**OPG Interim Response to Information Requests from the Joint Review Panel
May 20, 2010**

**OPG Response to Joint Review Panel Environmental Impact Statement (EIS)
Information Request May 2010**

OPG Response to Joint Review Panel Licence to Prepare a Site (LTPS) Information Request May 2010

FIGURE 1: Frequency of Wind Direction (Winds From 1996-2000 compared to 2008 and 2009)

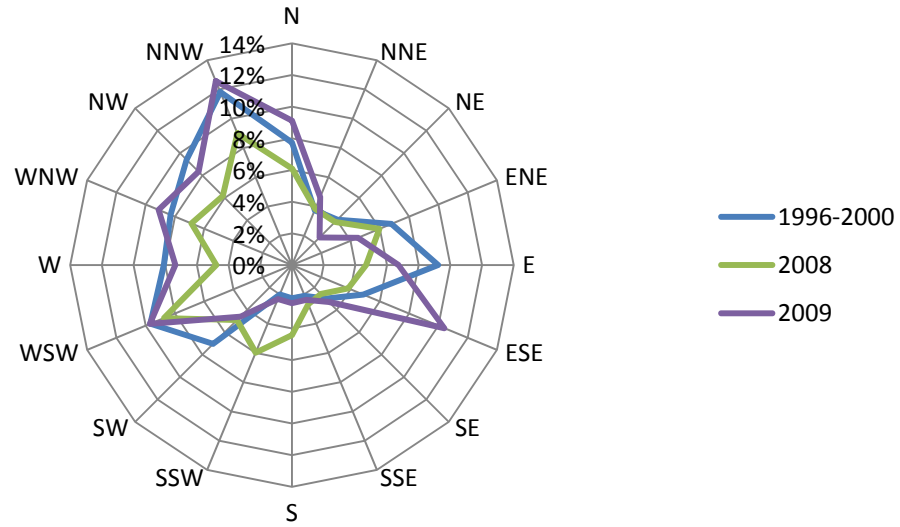
170	10.1.7 Climate, Weather Conditions and Air Quality	<p>JRP IR:</p> <p>As follow-up to IRs#105 and 106, provide the annual wind roses for 2008 and 2009 including the average wind speed and the percentage of calms. Compare the results with the data from 1996-2000. OPG has stated that "In order to improve data quality, procedural changes were made to increase scrutiny on the data provided by the DN meteorological tower. An annual availability target of greater than 90% has been set. Data unavailability will be reviewed and calculated on a quarterly basis to ensure an annual target is met." Provide details regarding the procedural changes and explain how the 90% annual availability target was arrived at.</p>

EIS IR#	EIS Guideline Section	Detailed Information Request and Response												
		<p>Rationale:</p> <p>Local wind data for the period 1996 to 2000 has been used to support the dispersion modelling for the EIS. Normally it would be expected that the five most recent years of available meteorological data would be used for Project dispersion modelling. In the responses to IRs#105 and 106, information was provided on quality issues discovered in the meteorological tower. The correction of problems with the monitoring equipment should enable reference to recent information to confirm that the monitoring data from 1996-2000 are valid.</p> <p>OPG Response:</p> <p>The annual wind roses for 2008 and 2009 including the average wind speed and the percentage of calms have been reviewed and provided in this response. Overall, 2009 meteorological data compared well to the 1996 to 2000 period used for the Environmental Assessment (EA). The meteorological tower data from 2008 was expected to be problematic as the quality issue was discovered midyear in 2008, and corrective actions as discussed in the OPG responses to IRs #105 and #106 have been implemented.</p> <p>The annual wind roses for 2008 and 2009 are provided in Appendix 2 to Attachment A, "EIS 170: Wind Roses for Darlington Nuclear (DN) Meteorological Tower" along with a comparison to data from 1996 to 2000. The average wind speed and the percentage of calms are provided in Table 1 below. The wind roses, and average wind speed and percentage calms in 2009 (Table 1) compare favourably to the 1996-2000 time frame. There is some variability in the wind direction, but that is to be expected for a one year time frame, and the overall wind pattern is similar to the one observed in 1996-2000. The data in 2008 is incomplete, and consequently the wind rose and percent calms do not compare well. Potential issues with 2008 data include missing data between February 18th and March 5th. Also, there are substantial periods of time during which there are recorded wind directions, but no wind speeds (i.e. wind speeds = 0 m/s). This is the reason for the high percent calms.</p> <p>Table 1: Comparison of Average Wind Speed (m/s) and Percent (%) Calms</p>

<p>In order to improve data quality, changes were made to the Radiological Environmental Monitoring Program (REMP) procedure (OPG 2009) to increase scrutiny on the meteorological data. An annual unavailability limit of ten percent (10%) for the meteorological data was adopted based on the recommendation provided in the Environmental Protection Agency (EPA) Meteorological Monitoring Guidance (EPA 2000). Unavailability will be calculated on a quarterly basis to ensure four</p>	Parameter	Period 1996-2000	Year - 2008	Year - 2009	Average Wind Speed (m/s)	2.6	2.6	2.8	% Calms	7.8	15.6	8.5
Parameter	Period 1996-2000	Year - 2008	Year - 2009											
Average Wind Speed (m/s)	2.6	2.6	2.8											
% Calms	7.8	15.6	8.5
